This document is a tool to help ensure appropriate due diligence has been taken prior to site clearance/works. Evidence is required to demonstrate all tree clearance has been suitably reviewed and can be justified.

Name	Signature	Date	
Application made by:	Sustainability Manager MDJV		19/07/2024	
Location (Sector/Site Name):	Interim Taxi Rank - Euston Square Gardens East			
LAA/LAP/Site Reference	N/A			
Work Package number:	N/A			
Date of Tree Panel:	26/07/2024			
Site Description:	Interim Taxi Rank - Euston Square Gardens East			
Reason for clearance:	Formative pruning to encourage vertical growth			
Drawing Reference No.:	N/A but annotated photographs as below section			
	Yes	No	N/A	Comments
Has the Stage 1 Survey been completed and logged on the Register	X			
	Yes	No	N/A	Comments
Has the Stage 2 Survey been completed with retention and protection measures logged on the Register			X

Photo 6: T029 – Indicative pruning areas

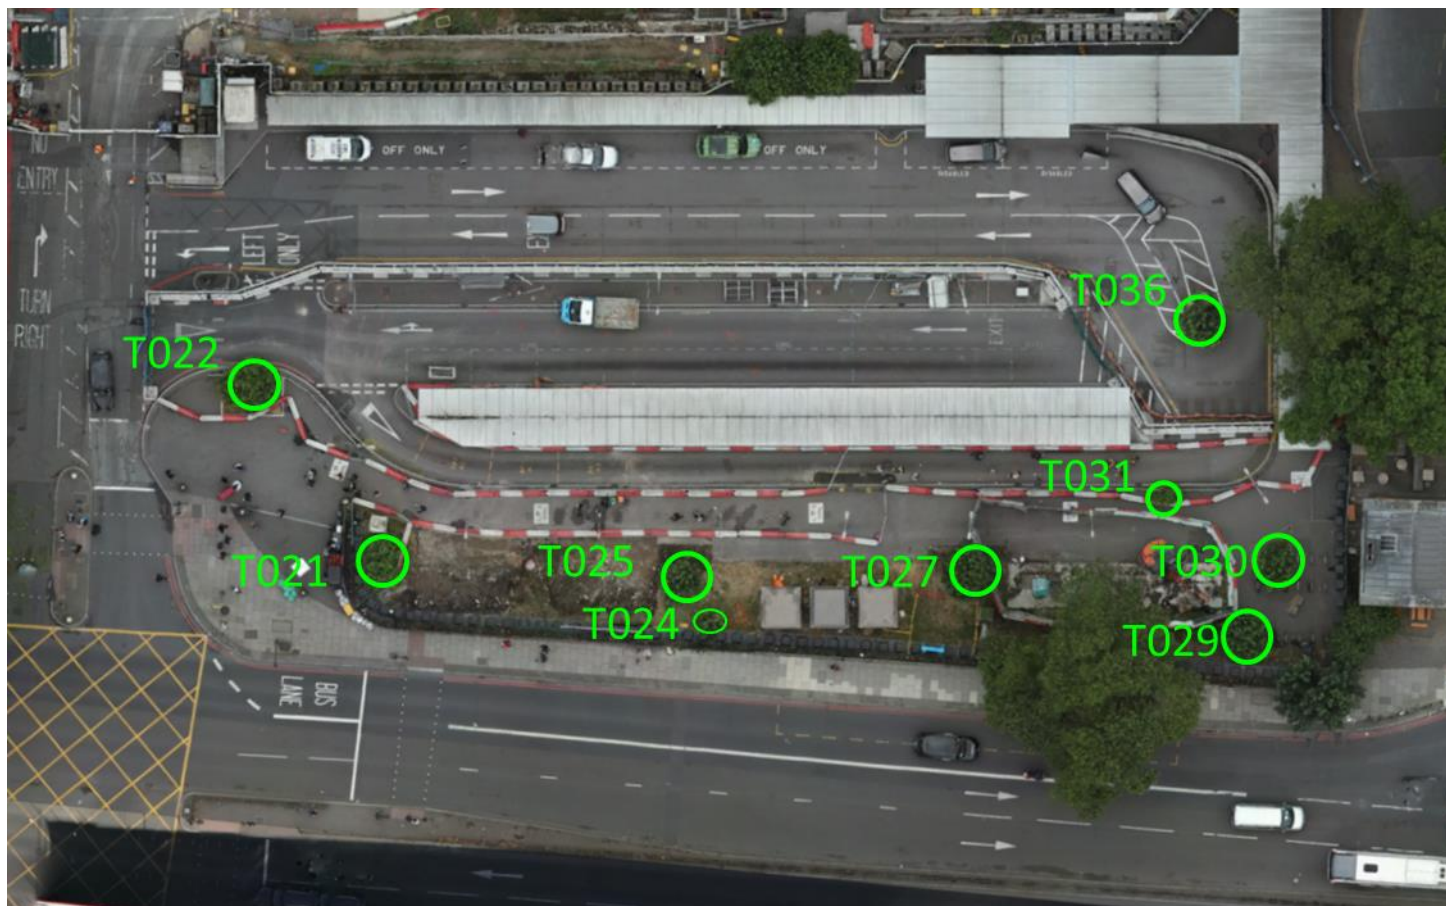
<p>Have all practicable means to negate need for works to tree been investigated? Please provide details</p>	<p>Under the instruction of the arboriculturist, undertake formative pruning of the regrowth from the stumps to encourage vertical growth.</p> <p>The main aim of formative pruning is to produce a tree which in maturity will be free from any major physical weaknesses (BS 3998:2010 Tree work – Recommendations)</p> <p>The formative pruning will predominantly focus on the removal of horizontal, lateral branches to promote apical dominance; however, it may also be prudent to thin some stems from the stumps to concentrate growth on fewer main stems. This helps direct the plant’s energy towards vertical growth and fewer strong shoots.</p> <p>The exact branches to be pruned will be decided on site based on the competent advice of the arboriculturist.</p> <p>Indicative mark up images provided in following slides.</p>

Proposal Endorsed/Not Endorsed:	Partial Endorsement (To36 only)
Conditions	To36 (only) in the taxi roundabout is endorsed for necessary pruning to enable safe use of the roundabout. The other trees listed above need to be brought back to panel in future if pruning is needed.
